## SYDNEY NORTH PLANNING PANEL ASSESSMENT REPORT

<b>Panel Reference</b>	PPSSNH-241
<b>DA Number</b>	DA0288/21
<b>LGA</b>	Ku-ring-gai
<b>Proposed Development</b>	<p>Construction of a two (2) storey sports complex, landscaping and associated works – St Ives High School - Crown Development.</p> <p>The overall development comprising four (4) sports courts will be known as the 'St Ives Indoor Sports Centre' ('SIISC') and will be jointly operated and managed by Ku-ring-gai Council and the NSW Department of Education.</p> <p>The SIISC is the second stage of development on the site, to be built directly adjacent to the first stage building St Ives High School Hall (SIHS Hall).</p> <p>This will provide an integrated complex of four sports courts.</p> <p>The joint venture is to be managed by Heads of Agreement with NSW Education which were adopted by Council at its meeting of 16 February 2021.</p>
<b>Street Address</b>	<p>60-70 Horace Street, St Ives</p> <p>Lot 4 DP 1209</p> <p>Lot 1 DP 122431</p> <p>Lot 1 DP 122432</p> <p>Lot 1 DP 376563</p> <p>Lot 5 DP 1209</p>

To determine Development Application No DA0288/21 for the construction of a two storey sports complex, landscaping and associate

*Proposed Landscape Plan and Planting Schedule, by Space Landscape Designs*

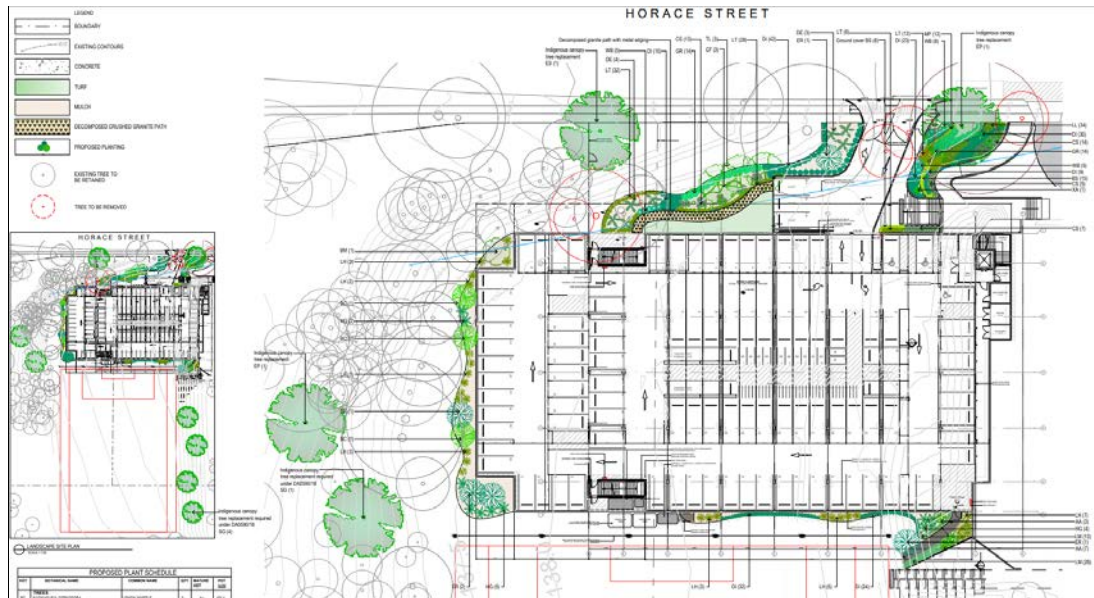
*The Rev I landscape plans are supported. Tree replenishment plantings to satisfy DA0590/18 and to offset tree removal for this application are satisfied.'*

The amended Landscape Plan provides appropriate layered planting around the facility, some indigenous canopy trees and native shrubs and grasses.

In terms of the screening of the Horace Street frontage, the Landscape Plan proposes 2 (2) *Eucalyptus saligna* (Turpentine – 25m mature height) at each corner of the building, infilled with a range of: Blue Gem Westringia (1m mature height), Gynea Lily (1.8m mature height), Scarelt Bottlebrush (1m mature height), Grevillea (0.8m mature height), Luscious Water Gum (8m mature height), Corymbia 'Summer Red' (mature height 5m). This variety of heights and foliage types is considered to provide a landscaped foreground and some appropriate screening, consistent with Ku-ring-gai planning objectives and landscape values.
